Groundwater Transfer Review Summary Form

Transfer/PA # T- 13633

Application: T-13633

Applicant Name: Water Wonderland Improvements District

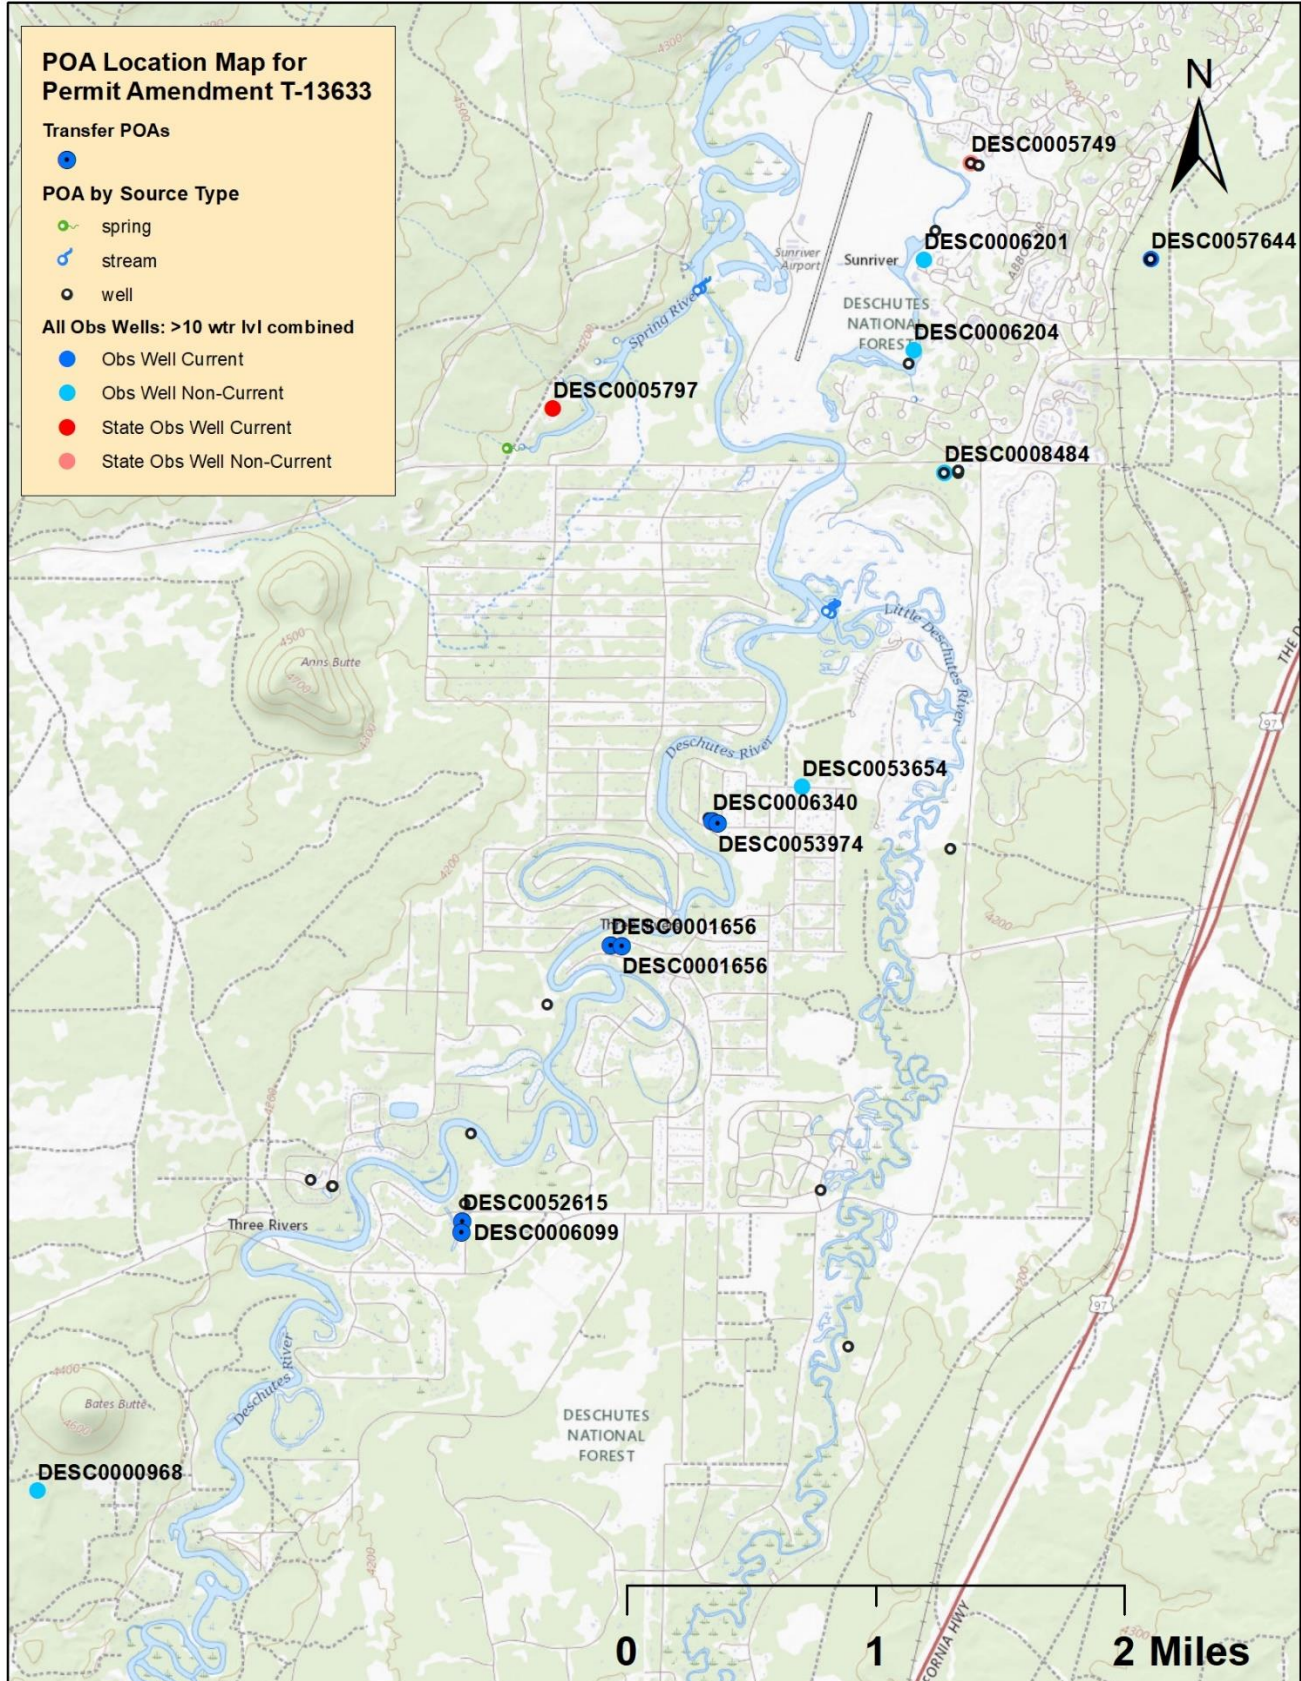
1. Basic description of the changes proposed in this transfer: Permit G-12649 currently authorizes 3.12 cfs of quasi-municipal use from DESC 6340 (0.76 cfs), DESC 1656 (1.25 cfs), and DESC 1441 (1.11 cfs). This transfer requests to change POA from DESC 6340 to DESC 53974, to amend the location for DESC 1656, and change POA from DESC 1441 to DESC 52615. The transfer also requests to eliminate the well specific rate limitations so any POA could pump at the total maximum rate (3.12 cfs).

2. Will the proposed POA develop the same aquifer (source) as the existing authorized POA?
Yes No Comments: Generally speaking, the applicant's wells access Quaternary-aged alluvium in the La Pine basin with some interbedded extrusive volcanics. Water levels indicate that the entire system is hydraulically connected vertically. Replacement wells (DESC 53974 and DESC 52615) are drilled immediately adjacent to the current permitted wells. They are drilled deeper in a system that is vertically hydraulically connected.
